## Appendix D

### Fleet of the Future Final Train Car Model

#### North Berkeley Special Event Summary

## North Berkeley Layout - 04.29.14

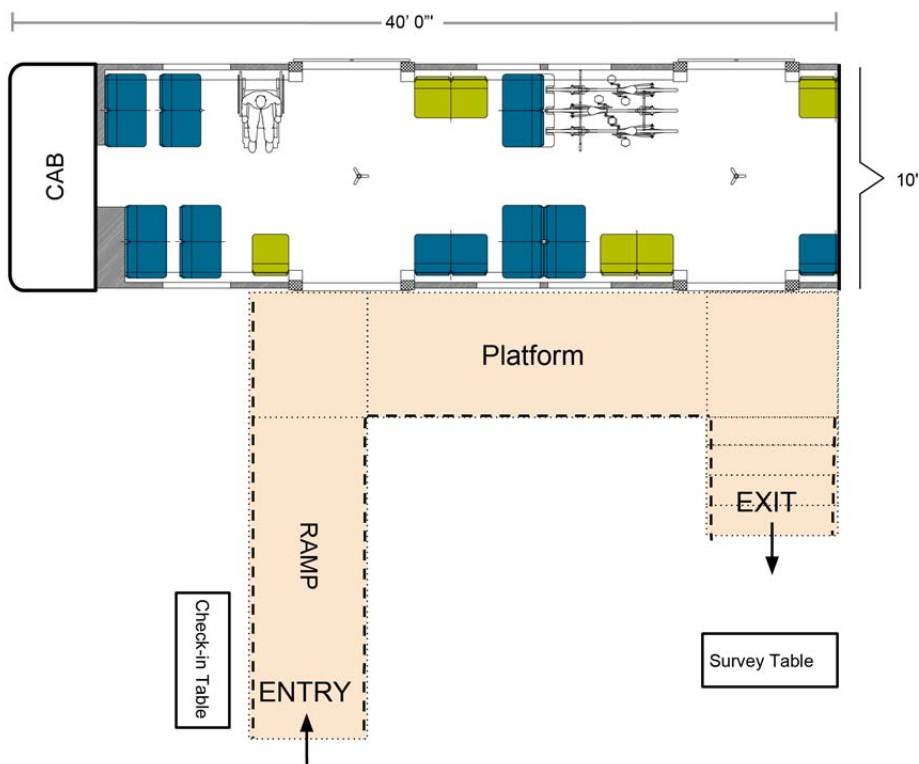
Of particular interest were participants' interactions with the new floor-to-ceiling pole located in the vestibule. Note that the floor to ceiling pole near the wheelchair area was offset to the right in order to provide a wider path to the wheelchair area. (The distance from this pole to the single seat to the left of the door was approximately 49 inches. The distance to the seat to the right of the door was approximately 43 inches. For reference, the width of the doorway was 54 inches.)

One participant reported that her guide dog made contact with the floor-to-ceiling pole when she first boarded the car. No other contact with the pole was observed or reported during the exercises.

Most (15) of the participants who used wheelchairs or scooters made their way to the dedicated wheelchair space using the direct path, i.e., proceeding diagonally from the open door, passing the left side of the pole. Three participants made a counter-clockwise partial loop around the pole first (entering to the right of the pole).

- Some participants felt that that this new pole would draw passengers to congregate near the doorways, making entering and exiting more difficult. There was concern that passengers holding onto the pole would not move out of the way quickly enough due to not paying attention.

- For wheelchair users, maneuvering around a crowd at the pole was the main concern, not actually hitting the pole.
  - Concerns about the pole were most common among passengers using wheelchairs and blind passengers.

- Some wheelchair users liked the pole because it gave them something to grab for safety.
- A couple of visually impaired passengers felt the contrasting stripes on the pole needed to be lower for better visibility, and more contrast was desirable. One noted that her guide dog had walked into the pole upon first entering the car.
